Staff recommends the HPC **approve with two (2) conditions** the HAWP application.

SIGNIFICANCE: Contributing Resource to the Takoma Park Historic District
 STYLE: Craftsman
 DATE: 1923

**APPLICATION FOR
HISTORIC AREA WORK PERMIT**
HISTORIC PRESERVATION COMMISSION
301.563.3400

Figure 2: 1927 Sanborn Fire Insurance Map showing the subject property.

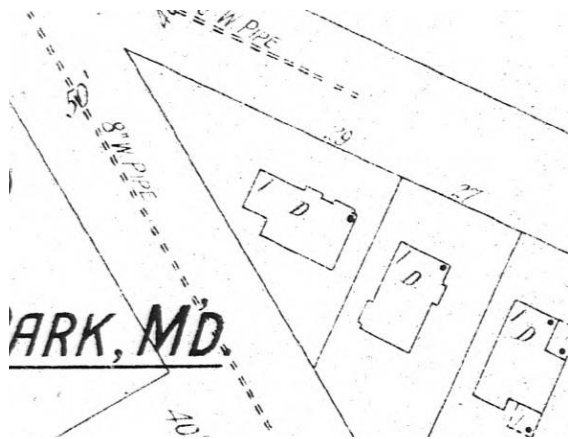
Staff's initial impression upon visiting the site was that the house had been modified to accommodate the garage door. That impression was likely due to the proportions of the garage itself and because the retaining wall changes from stone to concrete at the driveway. Staff reviewed the Sanborn Fire Insurance Maps for the property. The 1927 map did not show a garage (typically marked with an "A" for automobile) at the subject property. The notations for the 1959 map show there is auto storage at the basement level. Unsure if a basement garage was a novelty in 1927, Staff reviewed other Sanborn maps and identified five instances of basement-level auto storage. Having determined that the existing garage is not an original feature of the house, Staff recommends the HPC approve the removal of the garage door under 24A-8(b)(1) and Standard 2. Additionally, the proposal does not run afoul of the *Guideline* that encourages the retention of the original window and door size and shape.

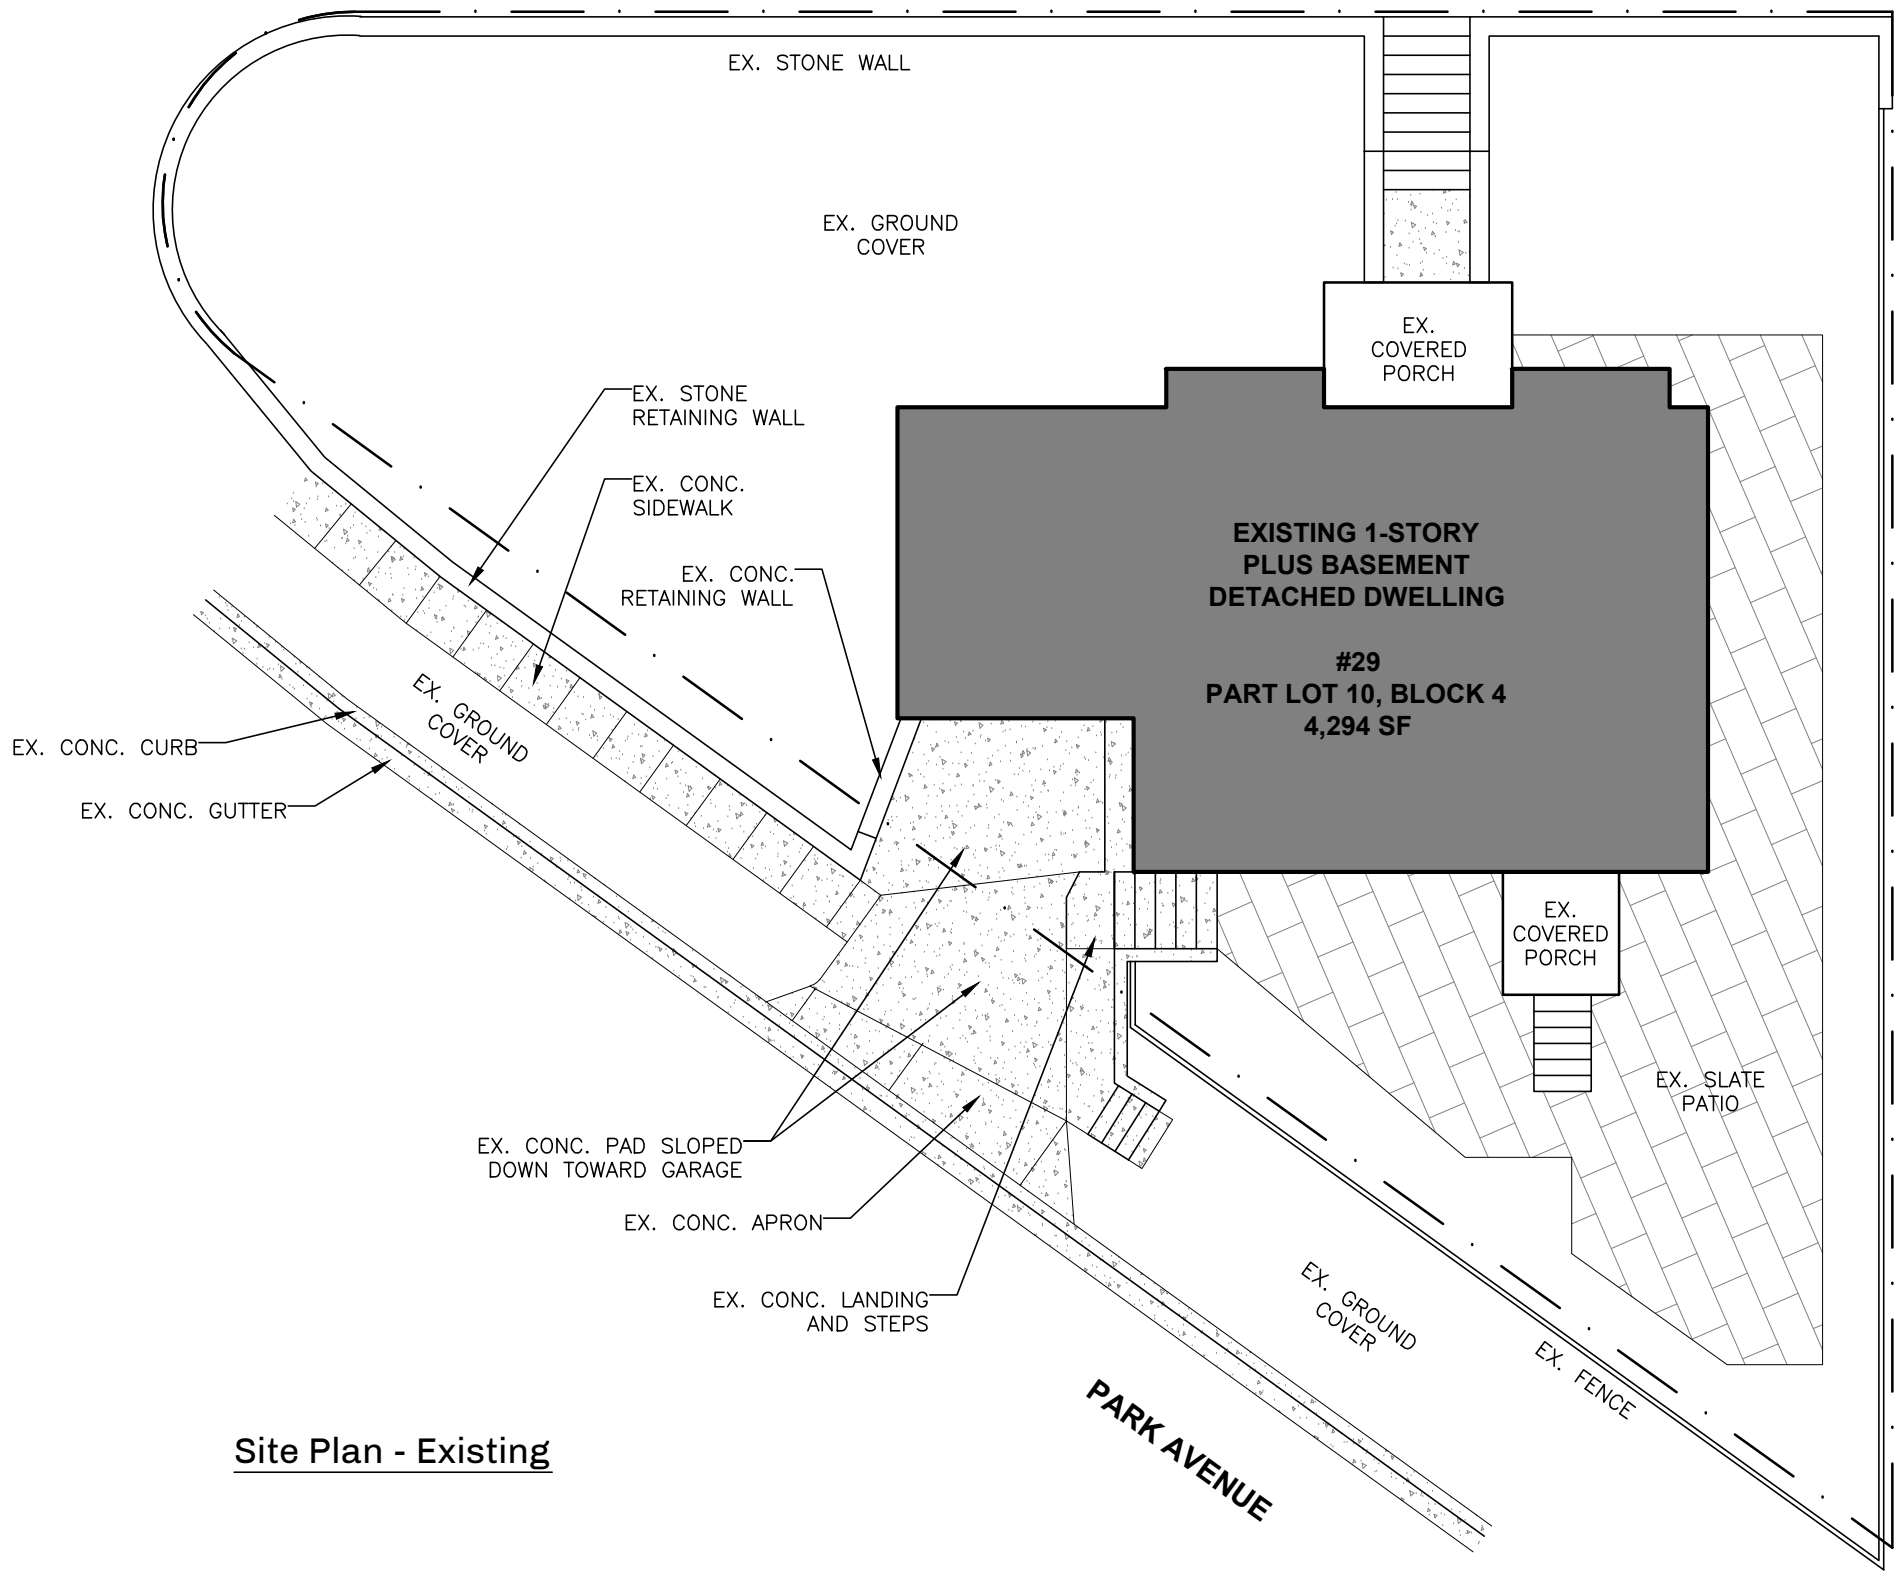
Staff finds removing the existing window on the front elevation will not significantly alter the historic character of the house, and the HPC has shown great leniency in altering basement windows for all categories of houses within the Takoma Park District. Additionally, the small window on the front does not likely satisfy contemporary code requirements. Staff finds the size of the proposed window, while larger than the existing, does not overwhelm either elevation – especially because they are at the basement level notwithstanding the *Guideline* mentioned above. Staff has two primary concerns with the proposed window. The first is that the single-lite configuration is incompatible with the historic multi-lite windows. Staff finds the basement windows should have a divided lite appearance. The proposed windows could retain their awning operation but would need to instead resemble a sliding window or multi-lite casement. Staff's second concern is the window material. Because a window specification was

not submitted with the application, Staff provide a recommendation to the HPC. However, because these are basement windows on a 'Contributing' resource, Staff would support the approval of a wood or aluminum-clad window; but not vinyl or metal. Vinyl windows are uniformly discouraged within the District on historic buildings, and metal is not appropriate for the basement level. Staff recommends the HPC approve the proposed basement windows with an added condition that the basement windows need to be either wood or aluminum-clad windows with a multi-lite configuration, with final approval authority delegated to Staff.

1. The proposed windows shall be wood or aluminum clad with a multi-lite appearance and exterior applied muntins of an appropriate profile. Final approval authority for the windows is delegated to Staff.
2. The new concrete driveway shall be tinted or have exposed aggregate to blend in with the surrounding streetscape. Final approval authority to verify this condition has been satisfied is delegated to Staff;

Site Plan - Proposed

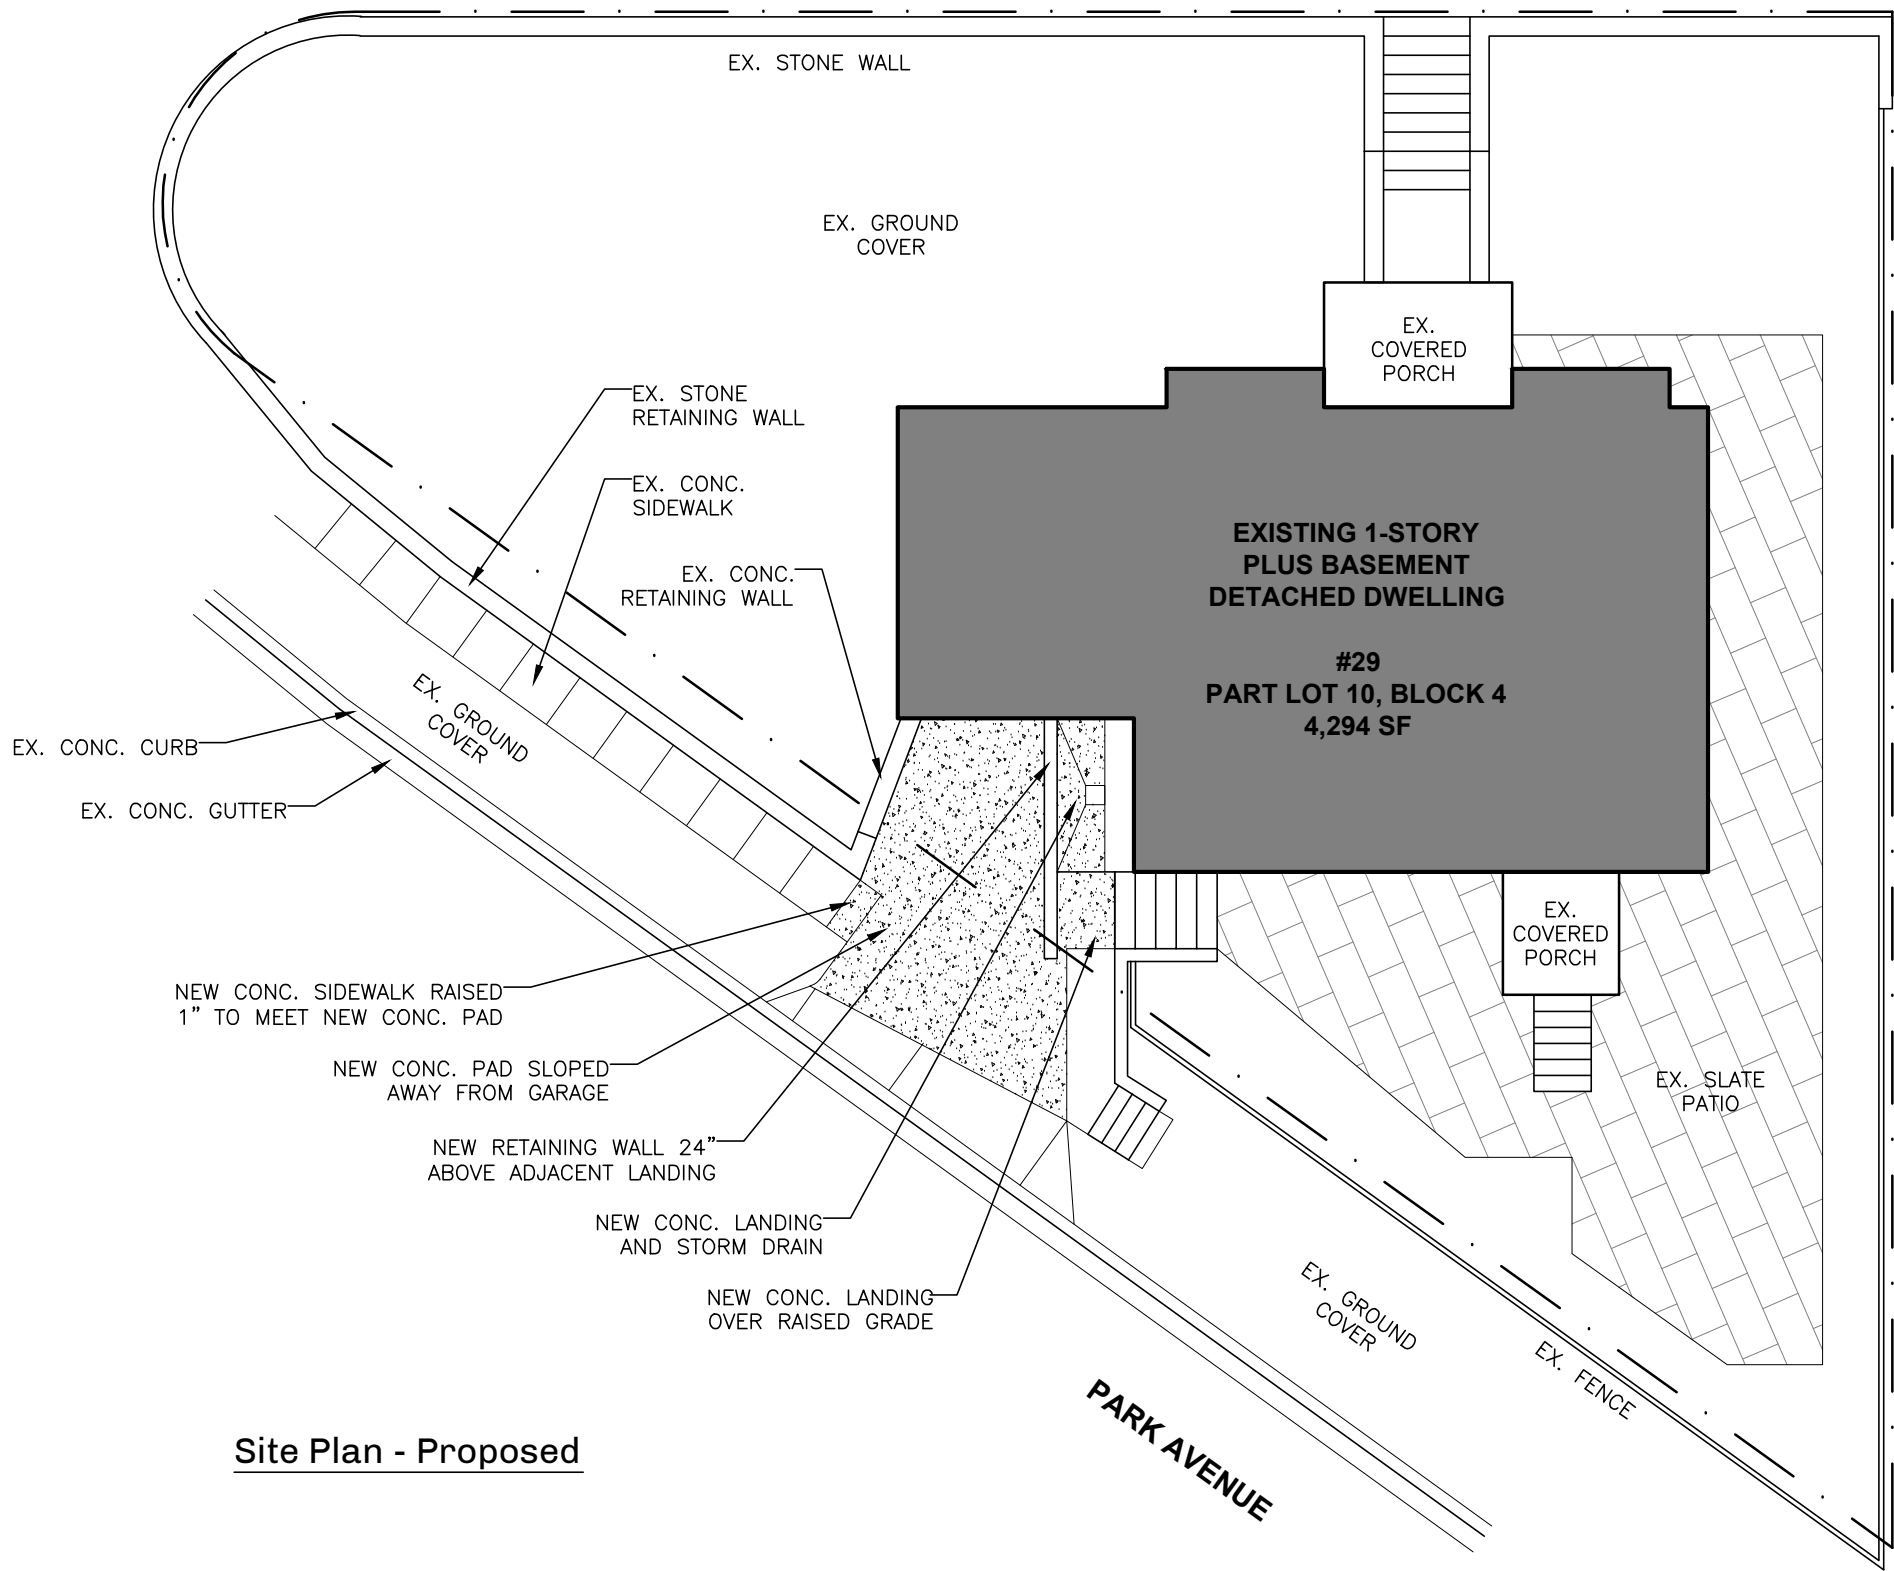
Staff finds the proposal will not significantly impact the historic character of the site or surrounding district. As with the windows, the applicant did not provide a concrete specification beyond 'concrete.' The HPC has avoided the installation of bright contemporary concrete in the Takoma Park Historic District because its bright appearance is visually inconsistent with the character of the district as a whole. The typical solution is to either tint the concrete so that it better blends in with the surrounding streetscape or use concrete with exposed aggregate. Staff recommends the HPC approve the new configuration for the rear garage with the added condition that the concrete is either tinted or has exposed aggregate to avoid the bright white appearance of contemporary concrete.
